RE: Percolation Test Report, Building Permit Denial (B14004489); 12330 Scaggsville Road
(Tax Map 40, Parcels 123)

RE: Variance request for replacement well location at 12330 Scaggsville Road.

SEWAGE DISPOSAL SYSTEM SPECIFICATIONS WORKSHEET

PERC CERTIFICATION PLAN

Property I.D. 12330 Scaggsville Road Lot # Date 5/4/2015
Sanitarian R Bricker Landscape Position Side Slope
% Slope Soil Type Contractor Level Land

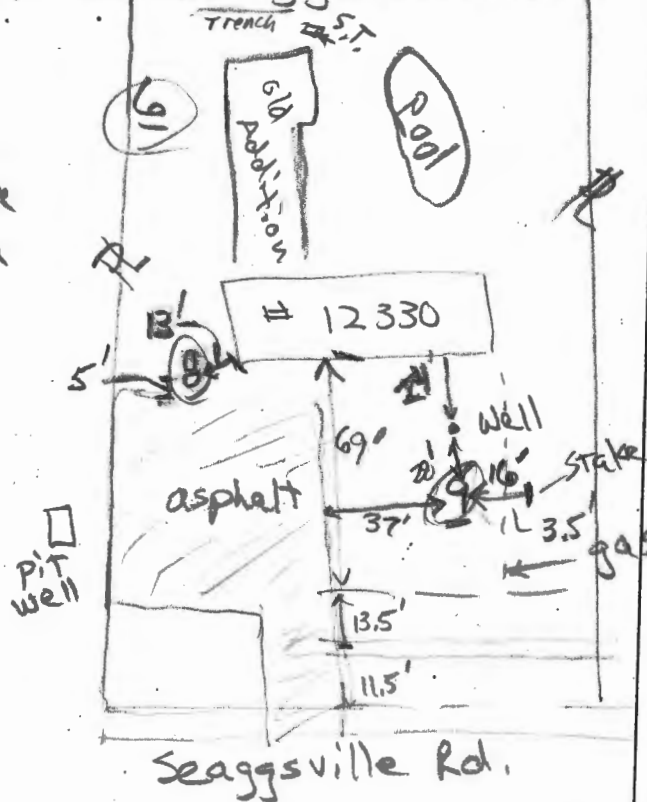
Four test locations, '4', '5', '6', and '7' were tested and/or described for standard subsurface trenches at marked locations. Three of the locations, '4', '5' and '7' FAIL for conventional septic system design. Only location '6' near the back-left corner of the existing structure is a PASS. The area represented by '6' is limited by the house foundation, the existing trench, and the 100-foot setback to the existing well.

Location '4B' was added in an attempt to define an area appropriate for a sand mound. The location is a FAIL as at 19 inches depth, only 1/16-inch of infiltration was observed after 30 minutes.

Additionally, the existing distribution trench was located and the soil profile ('TRENCH END') was described to the depth of the water table. The water table was observed at 7.5 feet depth and, as the TRENCH BOTTOM at the location is at 5 feet depth, the existing septic system is determined to not have the required 4-foot soil buffer. The existing septic system does not meet current Code requirement [Code of Maryland Annotated Regulation (COMAR), 26.04.02.04.C(1)] whereas "conventional on-site sewage disposal systems may not be approved where there is less than 4 feet of unsaturated, unconsolidated material sufficient to attenuate effluent below the bottom of the on-site sewage disposal system except as provided in Section C(2) of this regulation" (concerns soil in the coastal plain province) "and Regulation .05V of this chapter" (regarding At-Grade Mounds).

Due to the observed conditions, and that your plans are to increase the number of bedrooms, the submitted Building Permit (B14004489) cannot be approved [COMAR, 26.04.03.F(4)].

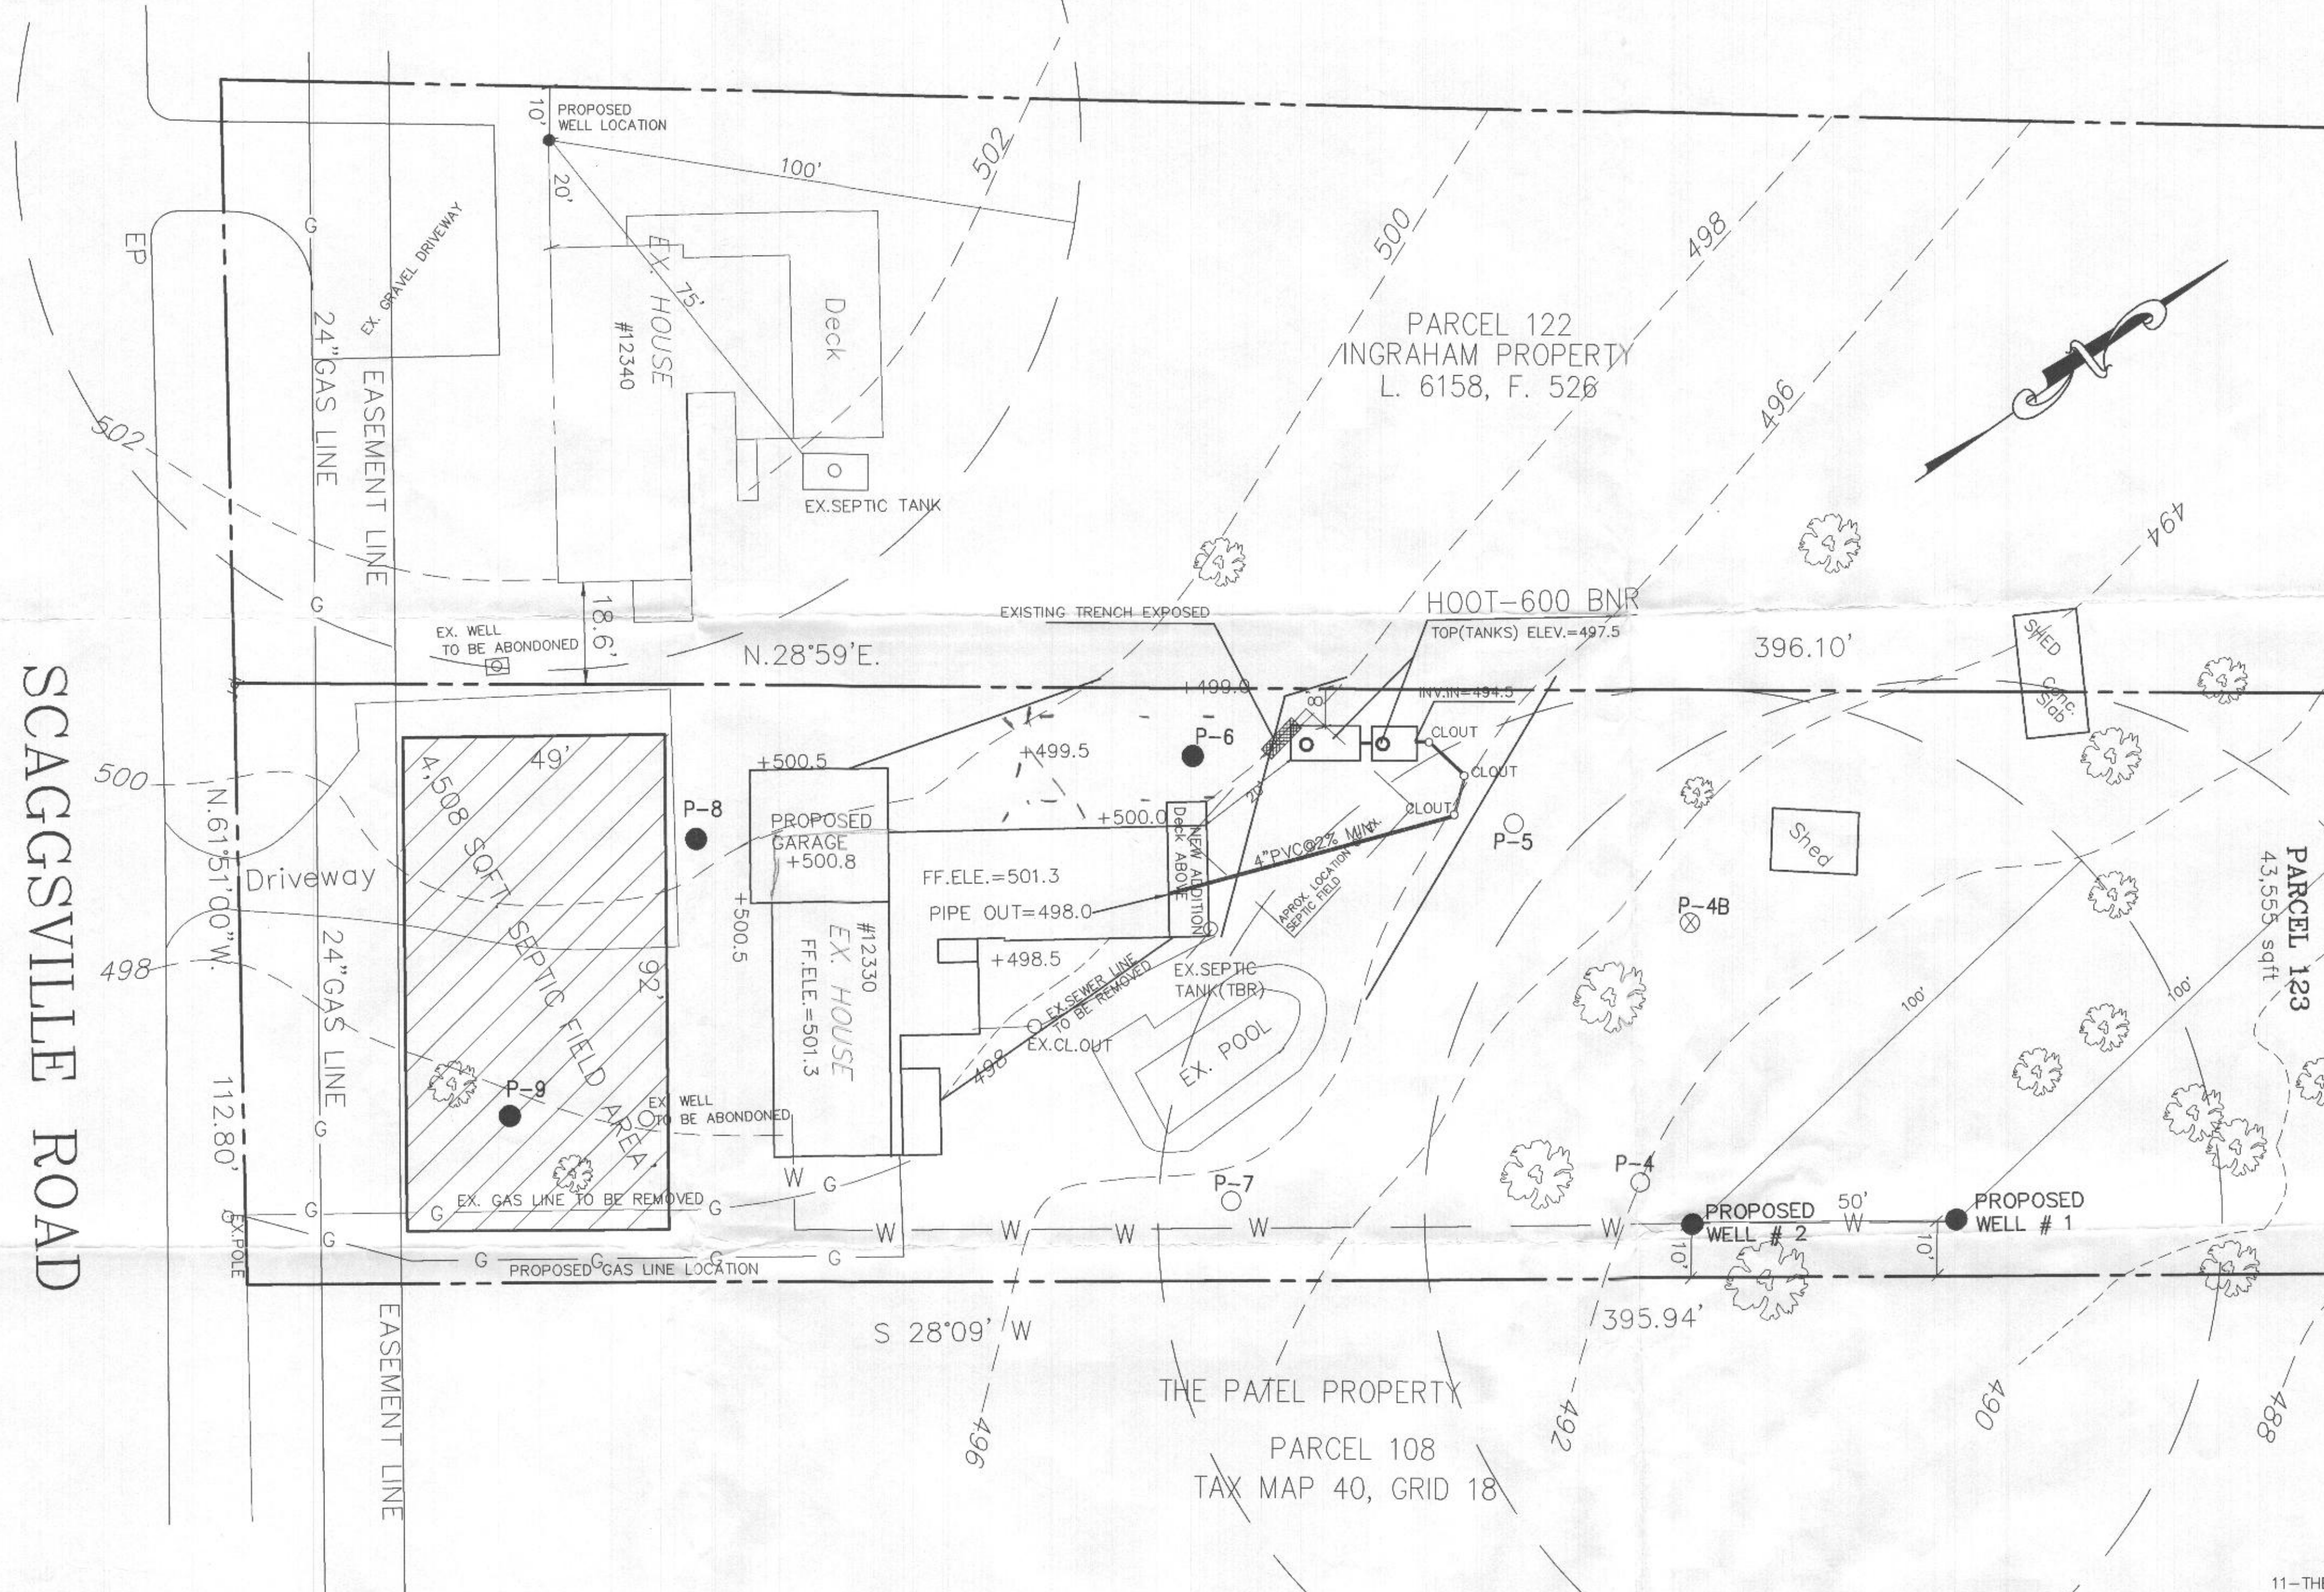
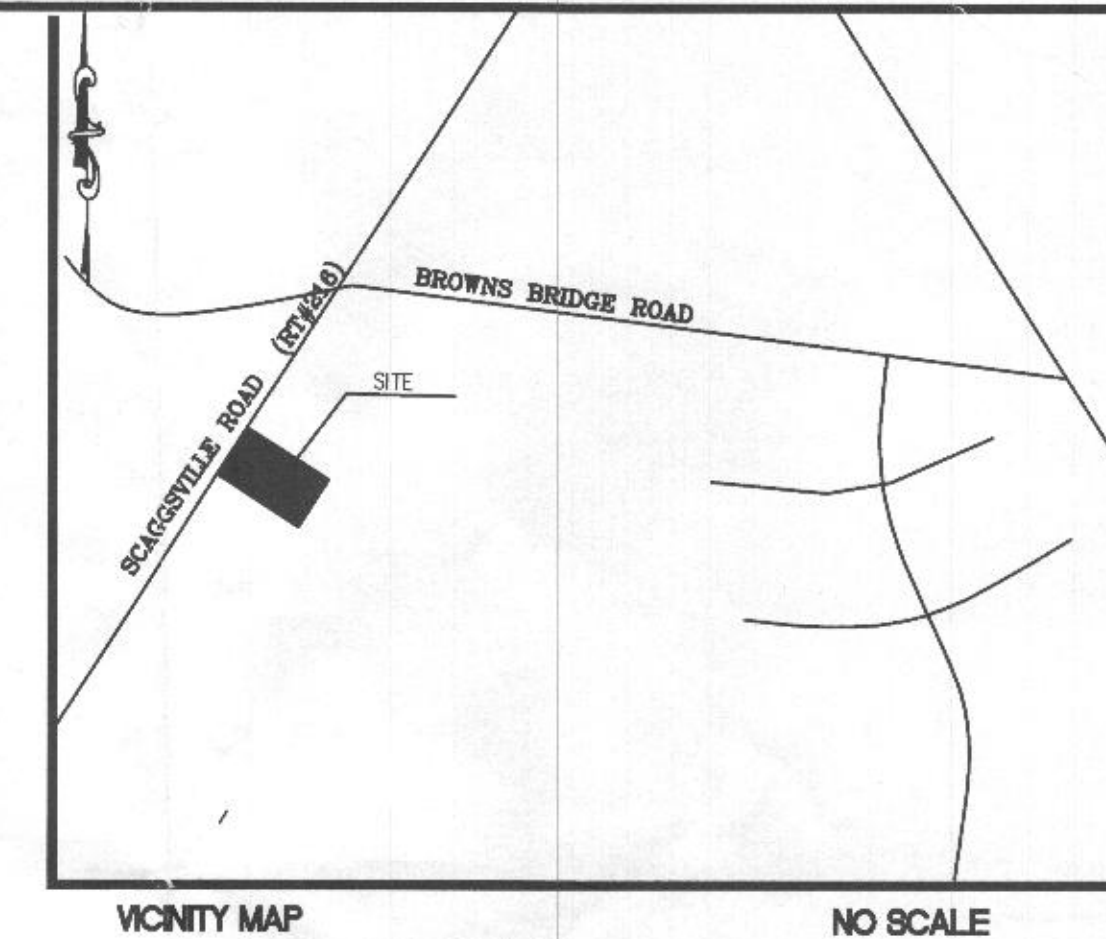
BAT required; initial drainfield to be installed under area currently covered with asphalt
